Summit West Village 22. Flight Range Ave (St. E)

CITY OF LAS VEGAS		DATE:
INTER-OFFICE MEMORANDUM		February 23, 2021
TO: Land Development Services Department of Building & Safety		FROM: Albert Sung, P.E. Flood Control Project Engineer Department of Public Works
SUBJECT:	Drainage Study for:	COPIES TO:
Summerlin West Village 22 - Flight Range Avenue (St. E) (Desert Foothills Dr. to Kettle Ridge Dr.)		Atkins
Cross Streets:	Desert Foothills Drive & Flight Range Avenue	Howard Hughes Company, LLC
File Number:	F:\Depot\DSMemos\DS5421A.doc	Bart Anderson, P.E., DevCo
Parcel Number:	137-23-210-001	
Zoning Action:	N/A	
FEMA Flood Zone	YES NO X	
Proposed Storm Drain	YES X NO

The Drainage Study for the subject project has been reviewed and:

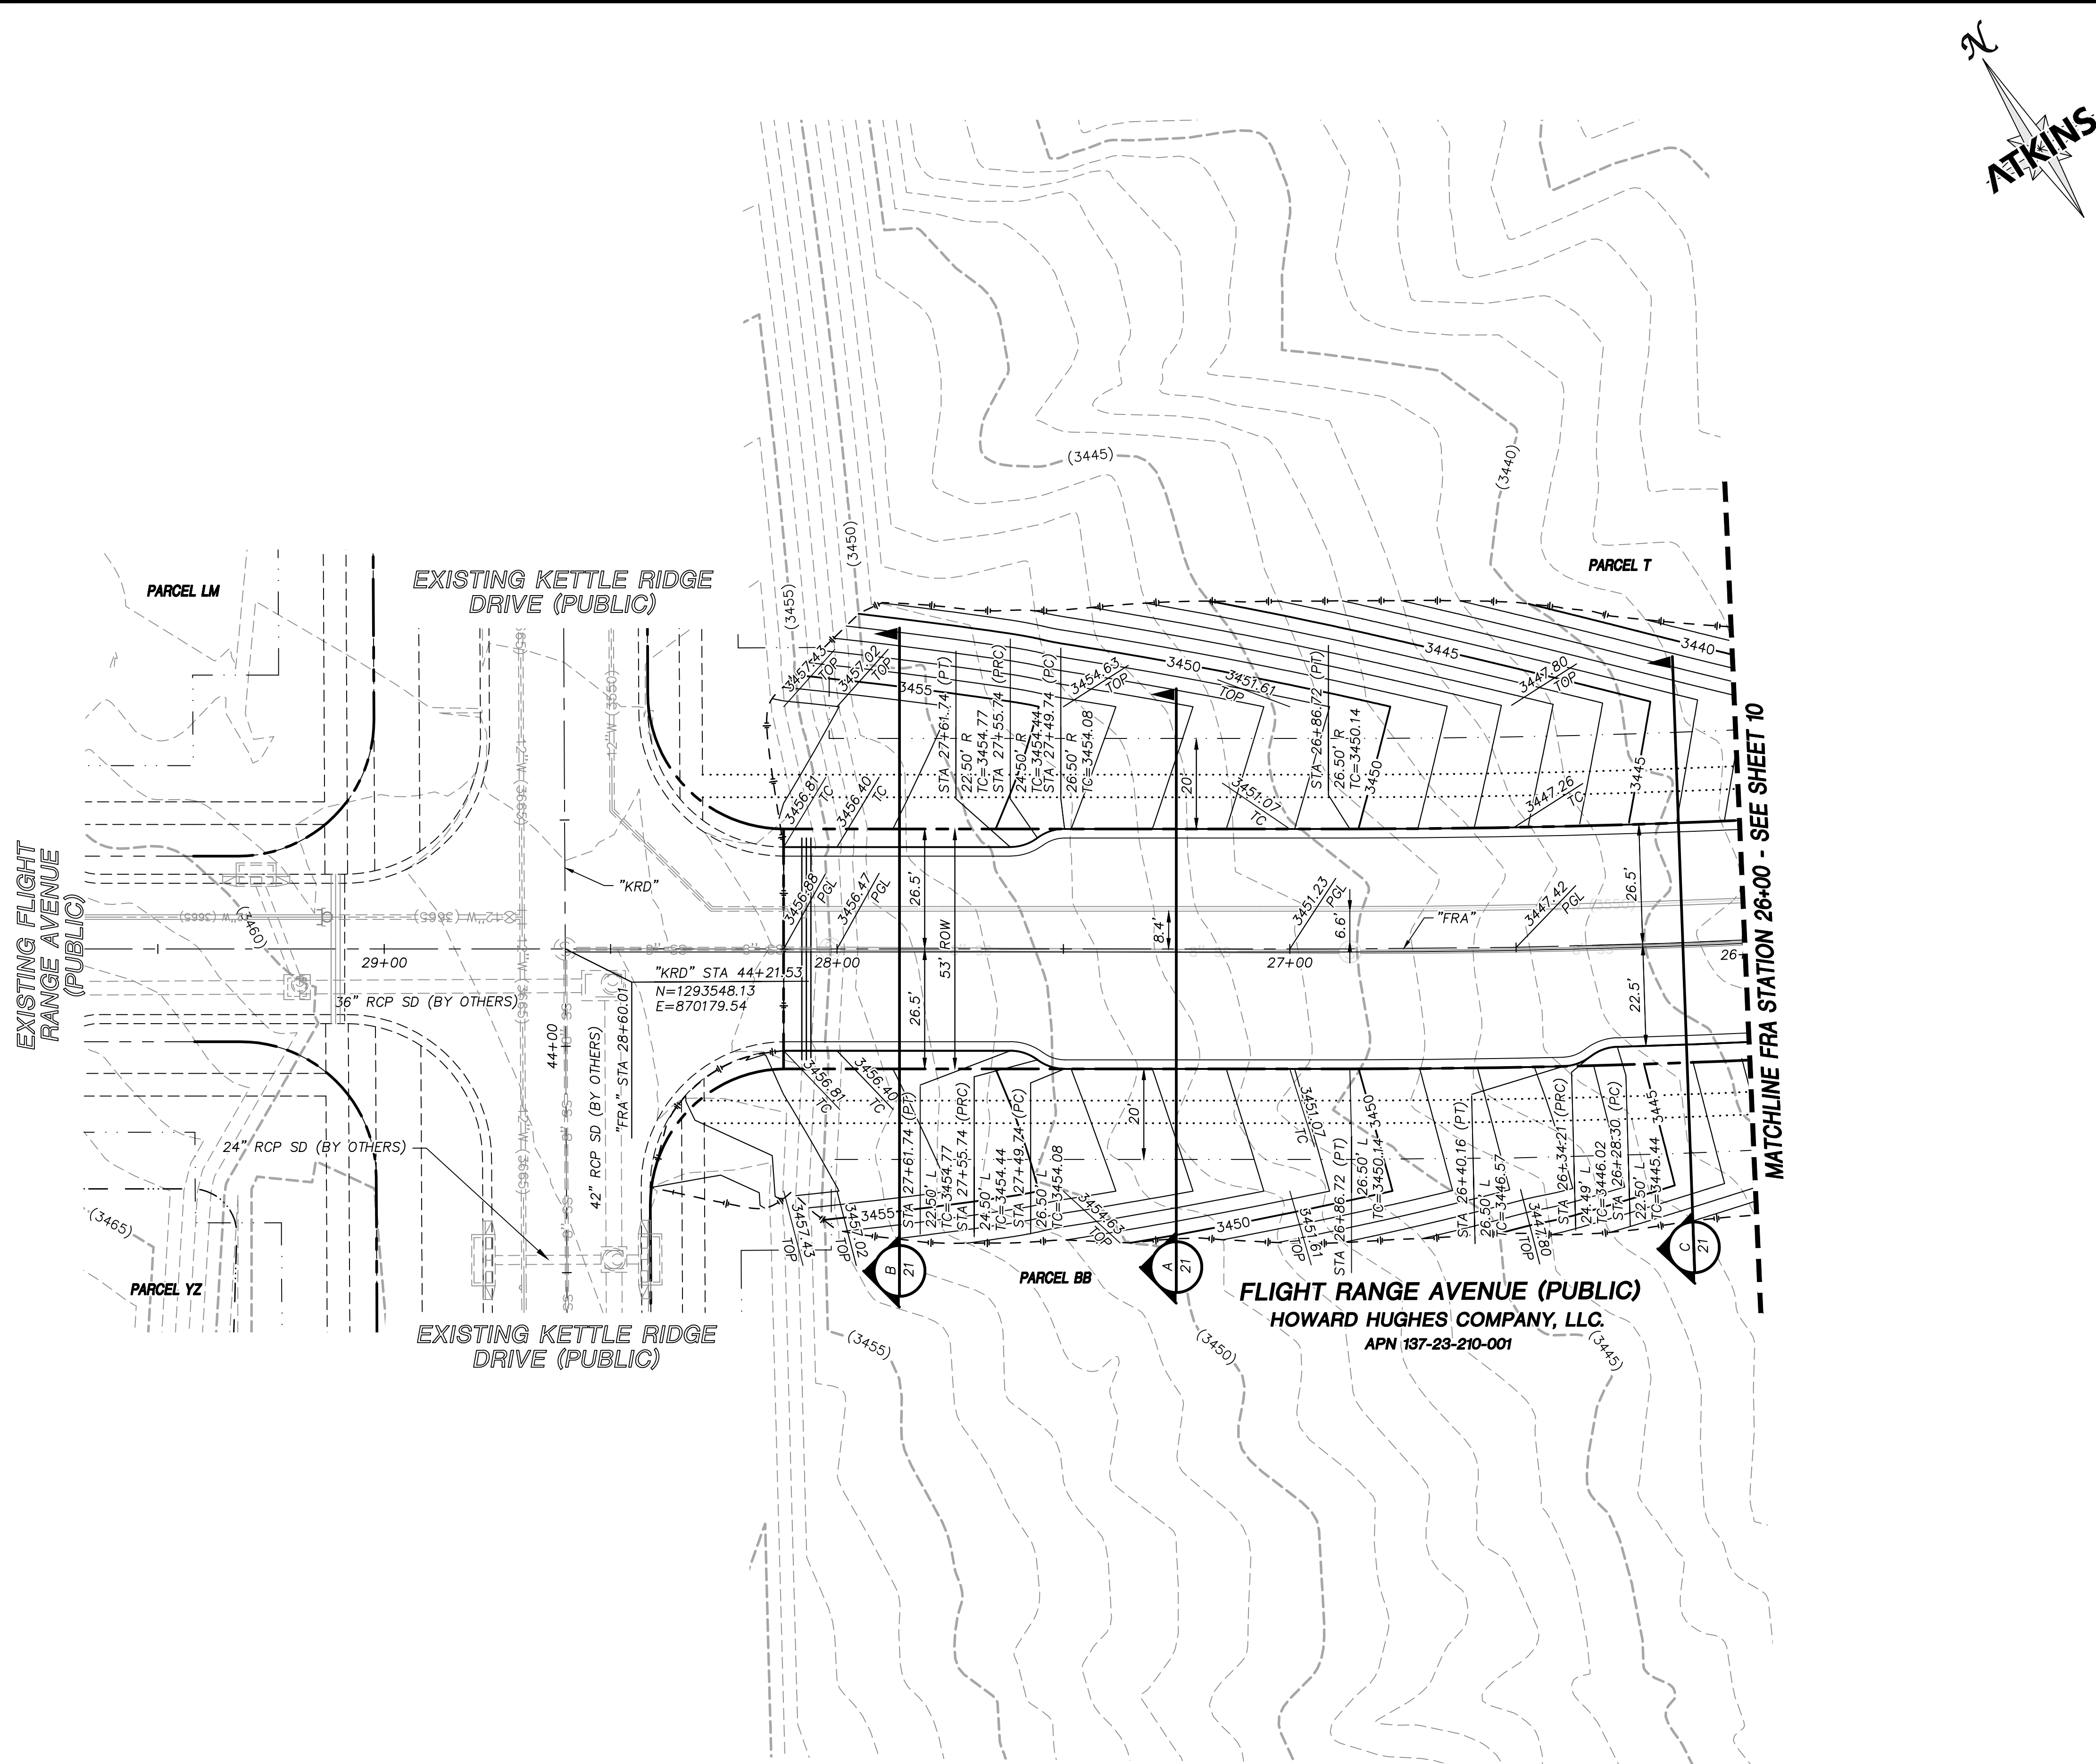
4. The HGL shown on the Plan and Profile sheets does not appear to match the HGL provided in the WSPG.
5. *Storm Drain Construction Note #7* proposed to install Type A drop inlet which is not allowed by the **City of Las Vegas** anymore. Use modified Type CM. Review and revise in the next submittal.
